CITY OF AUSTIN
Board of Adjustment/Sign Review Board
Decision Sheet

CASE NUMBER: C15-2014-0062

ADDRESS: 2601 CANTERBURY ST

VARIANCE REQUESTED: The applicant has requested a variance to Section 25-2-492 (D) of the Site Development Regulations to decrease the lot width requirement from 50 feet to 49 feet (existing) in order to re-subdivide this property in an "SF-3-NP" Family Residence zoning district. (Holly)

Potential subdivision of
 2601 Canterbury St 78702
 FULL REZONING DIVISION
 1" = 60'-0"
 03-25-2014

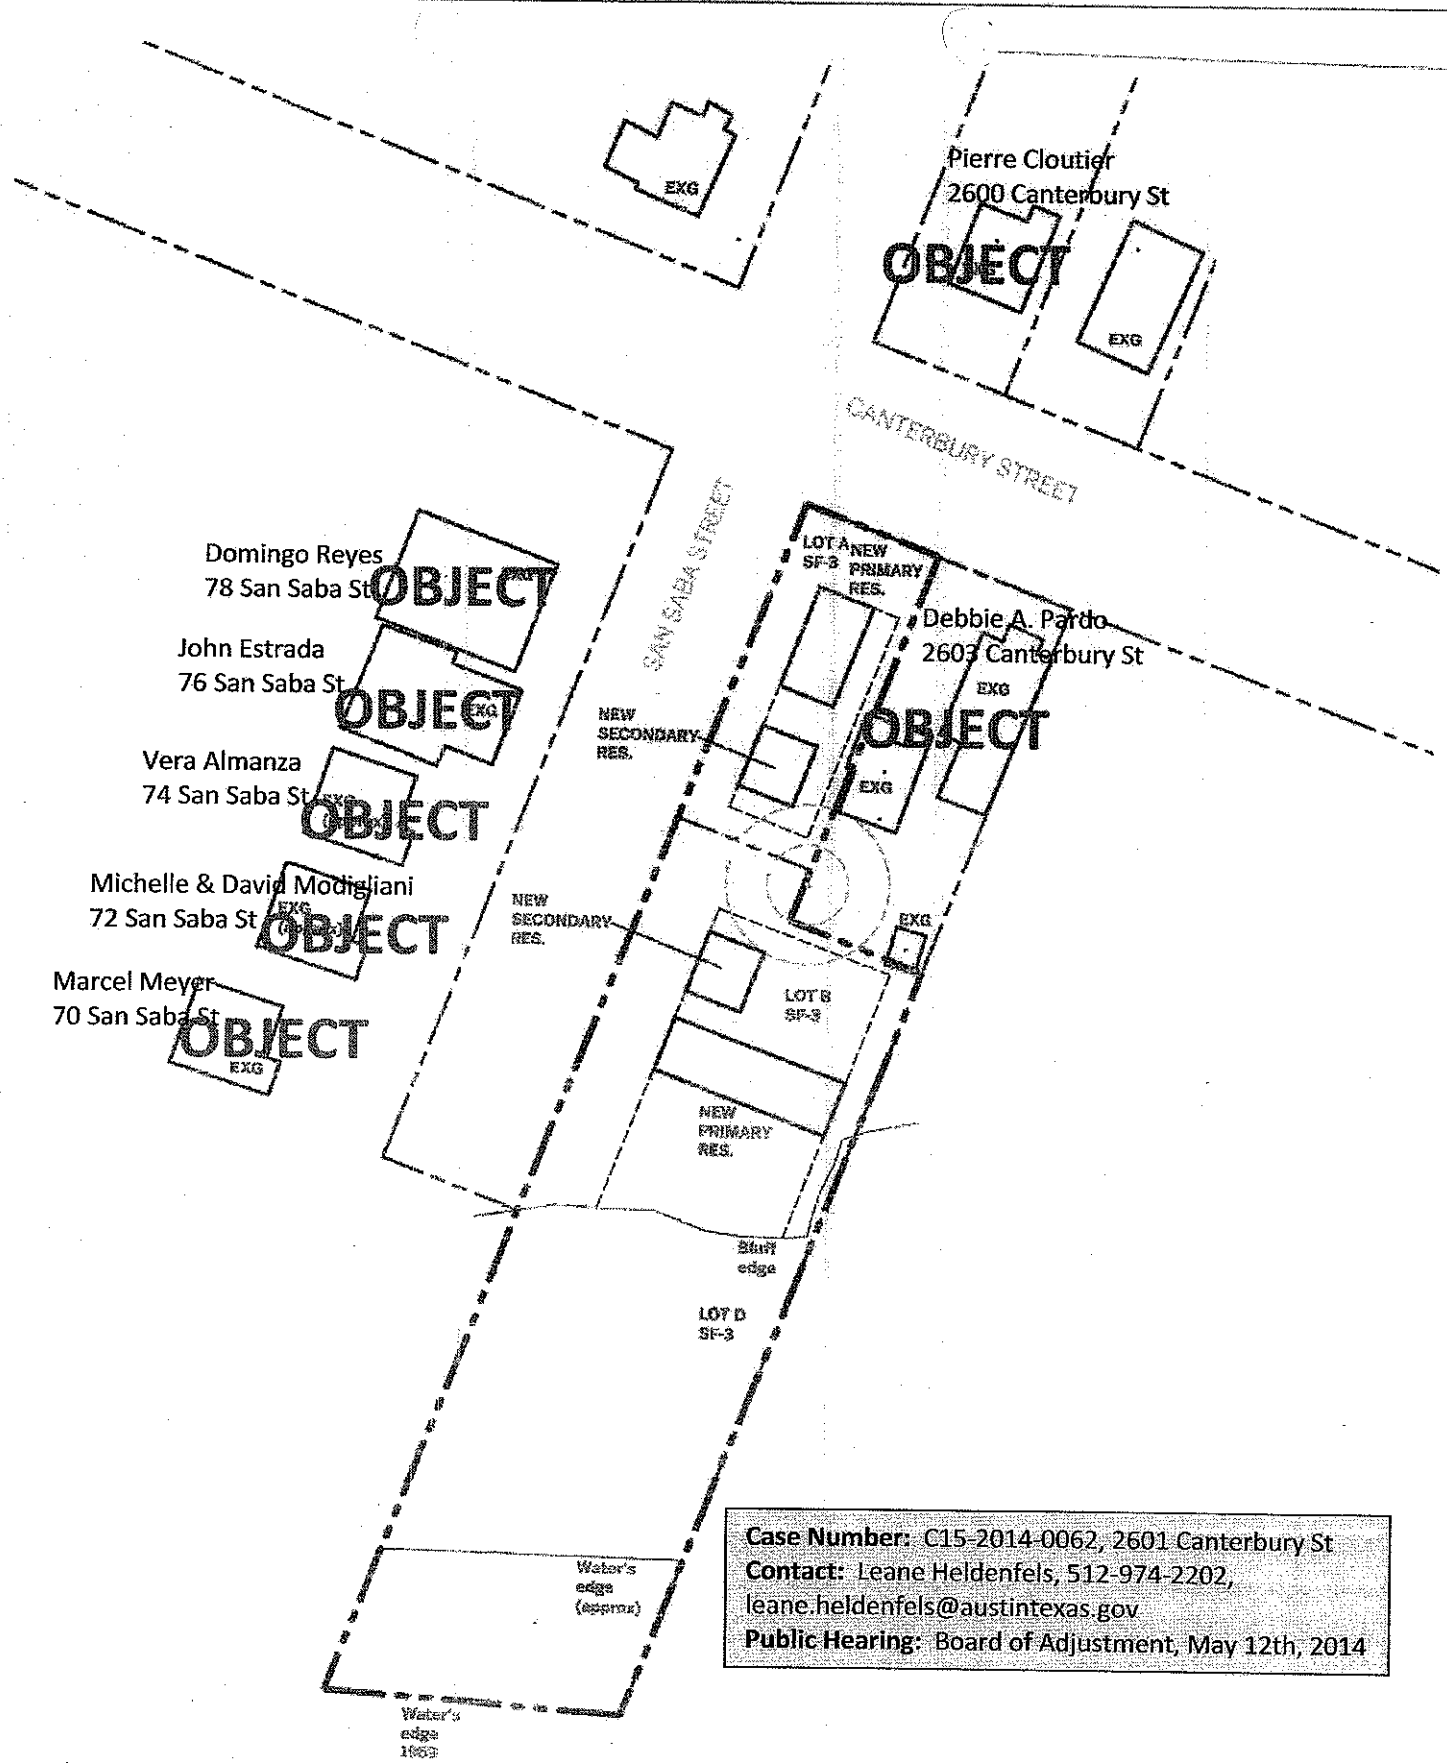
Case Number: C15-2014-0062, 2601 Canterbury St
Contact: Leane Heldenfels, 512-974-2202,
 leane.heldenfels@austintexas.gov
Public Hearing: Board of Adjustment, May 12th, 2014

The 7 property owners most directly impacted by the proposed variance and intended development have drafted and co-signed the attached letter. I am also attaching a map from the developer's application, marked to indicate the property owners that oppose the variance.

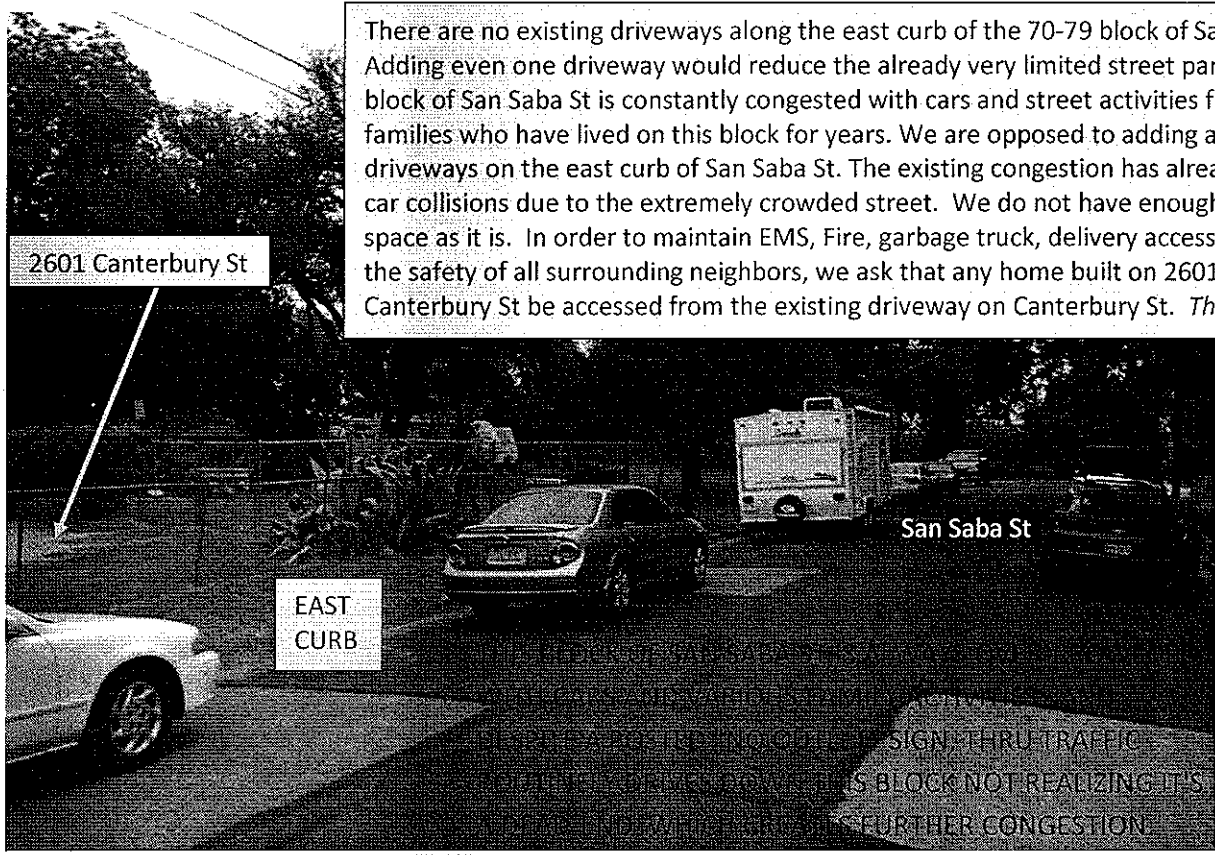
There are no existing driveways along the east curb of the 70-79 block of San Saba St. Adding even one driveway would reduce the already very limited street parking. This block of San Saba St is constantly congested with cars and street activities from existing families who have lived on this block for years. We are opposed to adding any driveways on the east curb of San Saba St. The existing congestion has already caused car collisions due to the extremely crowded street. We do not have enough parking or space as it is. In order to maintain EMS, Fire, garbage truck, delivery access, etc and for the safety of all surrounding neighbors, we ask that any home built on 2601 Canterbury St be accessed from the existing driveway on Canterbury St. *Thank you.*

We request that any home built on 2601 Canterbury St be accessed from the existing driveway on Canterbury St where there is abundant space, clear site lines and street parking for guests.

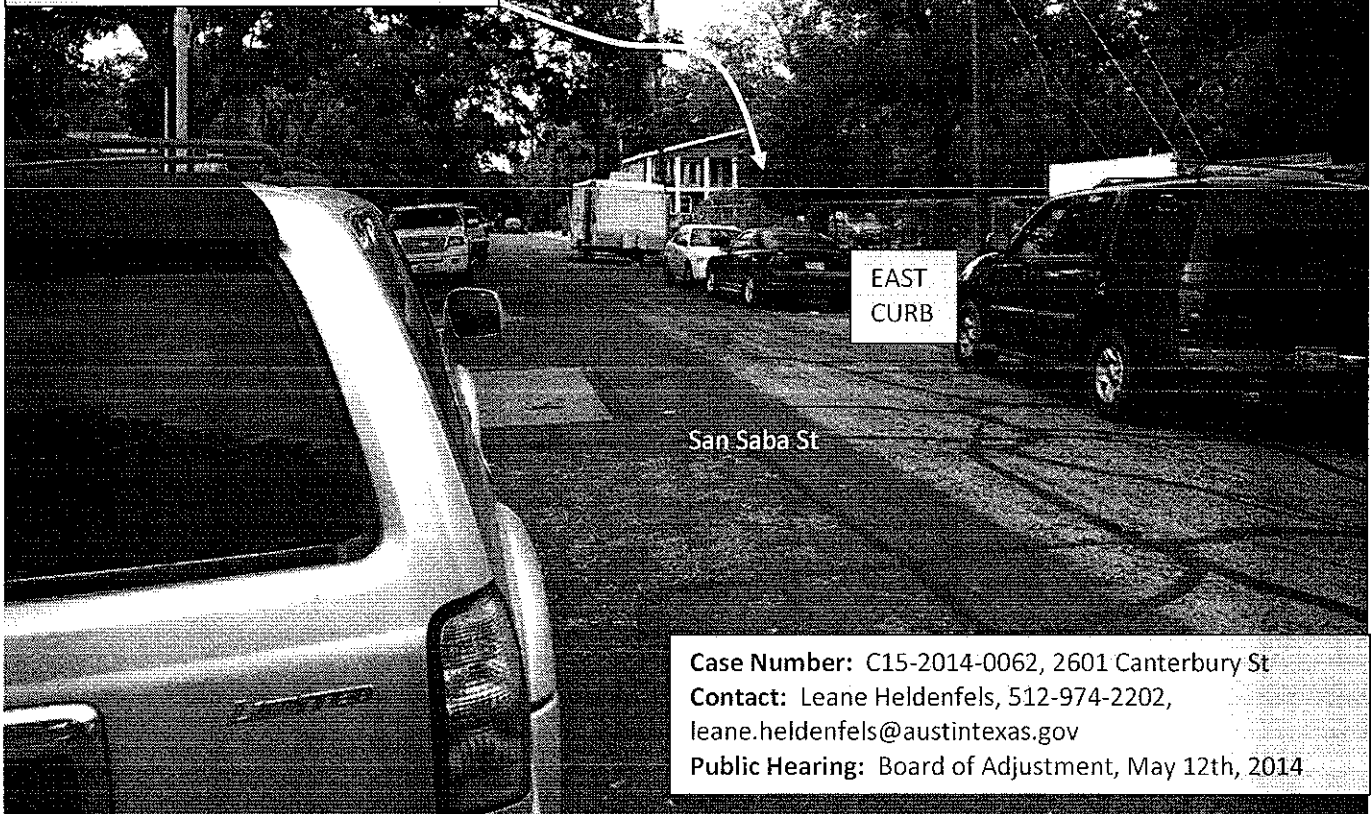
The 70-79 block of San Saba St is always full of vehicles & family activities. Less street parking would cause more frustration and unsafe maneuvering conditions for the families who live on this block. We ask the City of Austin to please consider our safety & livability.
